Access Compliance Report

Public Rights-of-Way

Intersection ID: 29214	Main Street: AUSTIN_SAMUEL_PL	Cross Street: CHRISTIAN_SCOTT_LN	Location: SE
ADA ID: 7F1BE9F3940E	Ramp Type: PerpDiag	Initial Pass/Fail: Fail	Overall Compliance: No
		Severity Score: 8.75

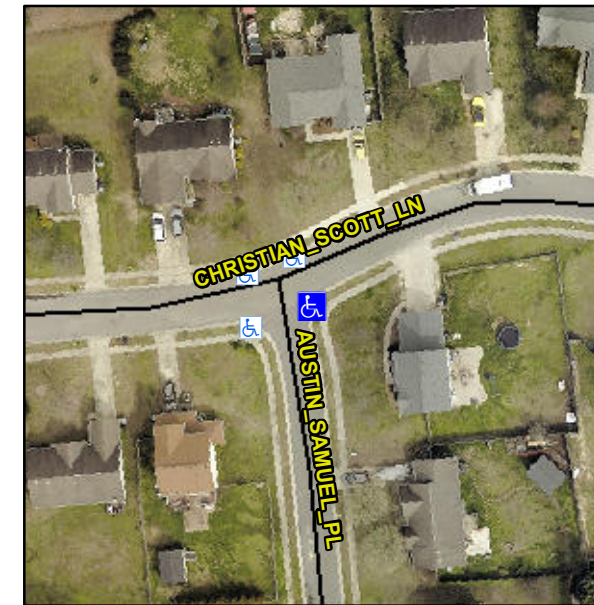
Not Found, R304.5.1

Remove & Replace Curb Ramp With Two New Directional Ramps or Equivalent.
